Notice of Appeal for "Park Street Municipal Drain"(Phase 1).

Meyer property looking through up the back of Martyn property to Stanley Property.

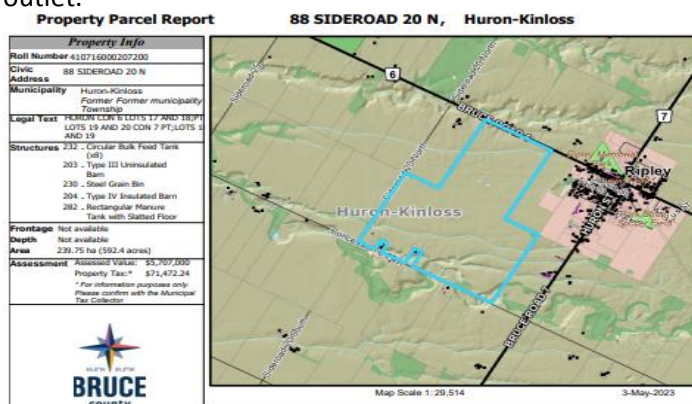
2. Also as per section 9.2.2 of the Report there is no mention of any work being completed on the Martyn Property (WS Plan#3) it is physically impossible to transition from (Plan #6 to Plan #2) without construction passing through plan #3.

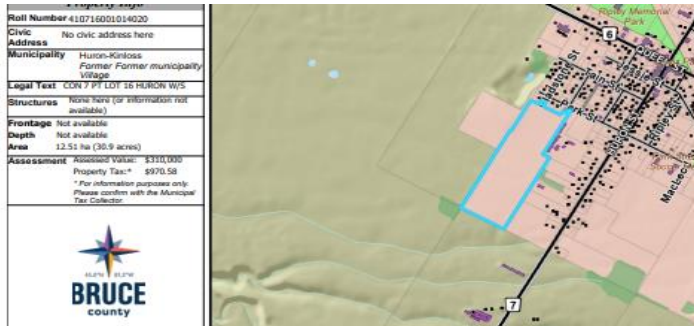
3. Final report has no Assessments for Roll #'s (02-072-00) Which is a 592 acre parcel that butts onto and outlets into the Fair Drain. I'm Not saying the whole 592 acres is to be assessed but there is at least 150 acres making its contribution based on elevation change towards the drain outlet.
